ORV2 Busbar Spec Update Proposal

Review of Current ORV2.1 Specification

Problem

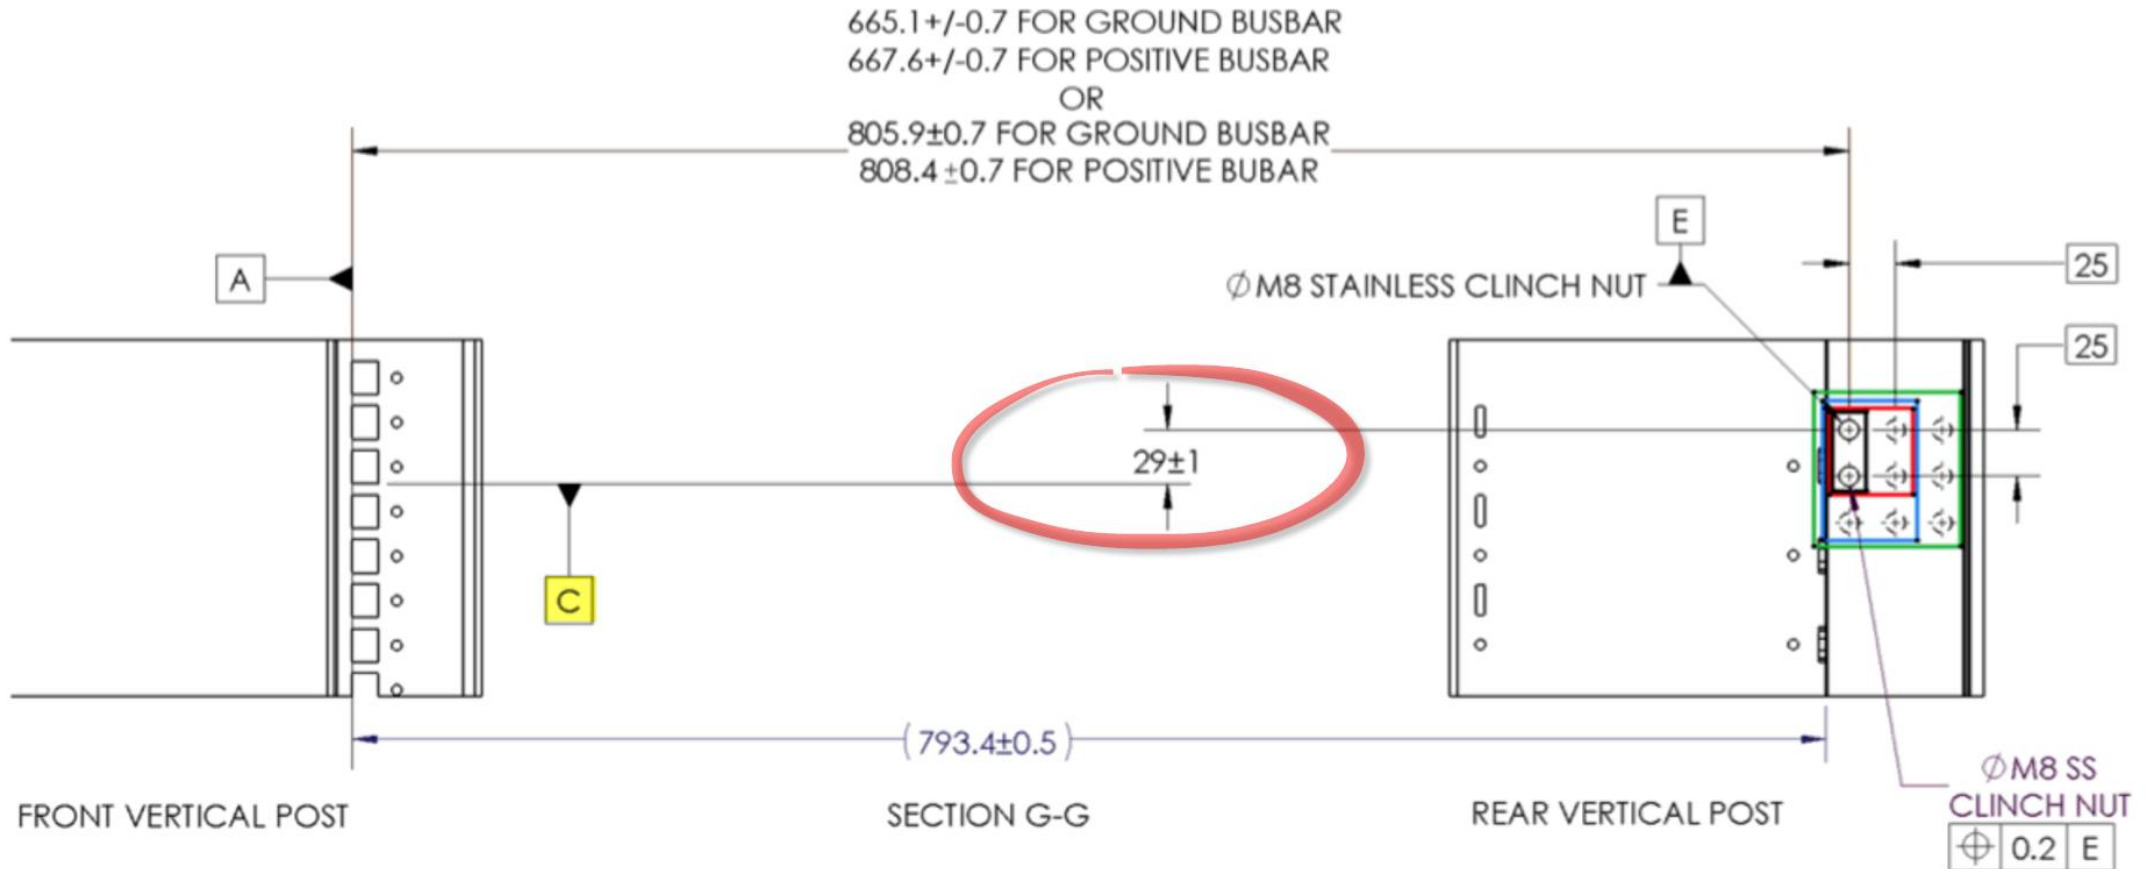
Section 2.5 is written around the use of a 3OU power shelf. Other configurations using 1OU power shelves require the power leads to have a dog leg design taking up space.

Misalignment Example

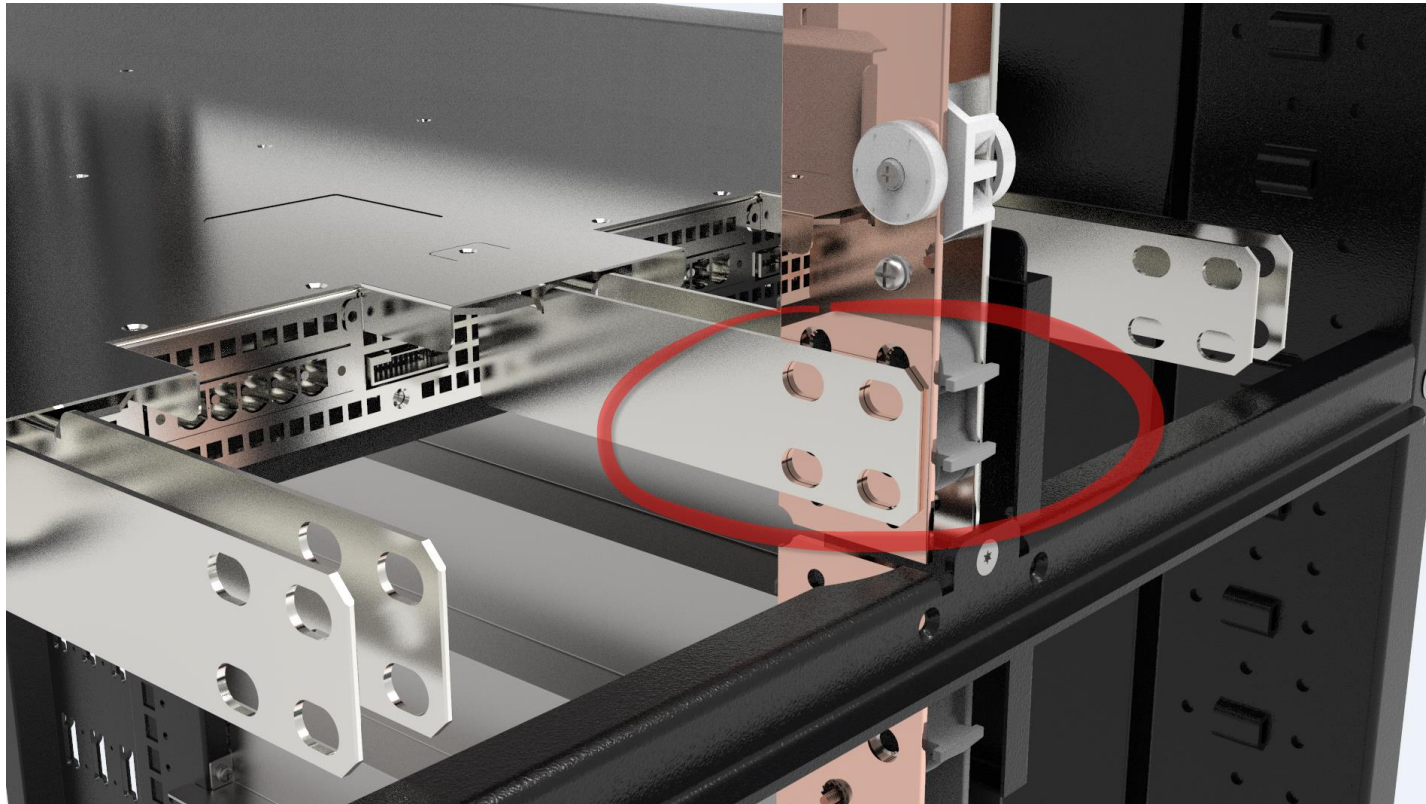
10U power shelf shown

Suggestion

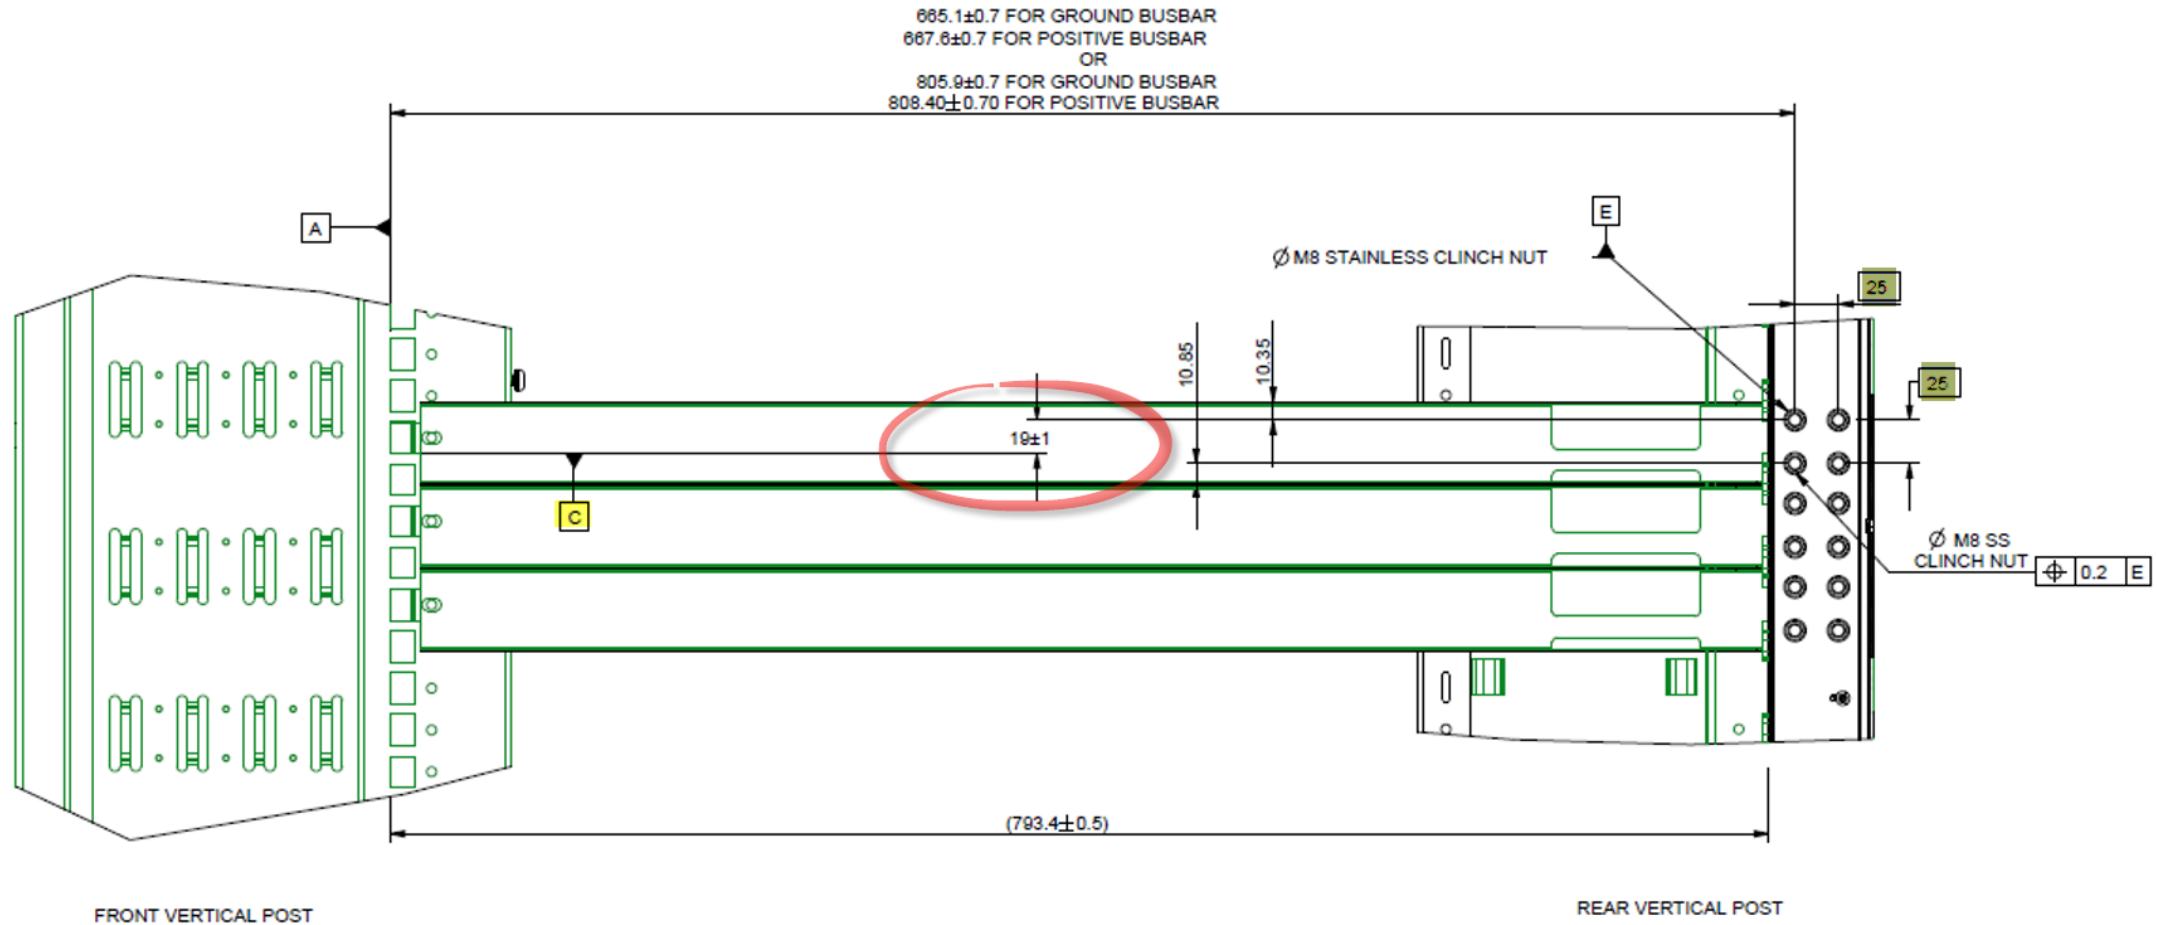
Update section 2.5.1.2 by adding additional bolt patterns options.

- Add additional bolt patterns like a 25 x 25 pattern at 19 +/-1 from datum C in addition to the current 29 +/-1.
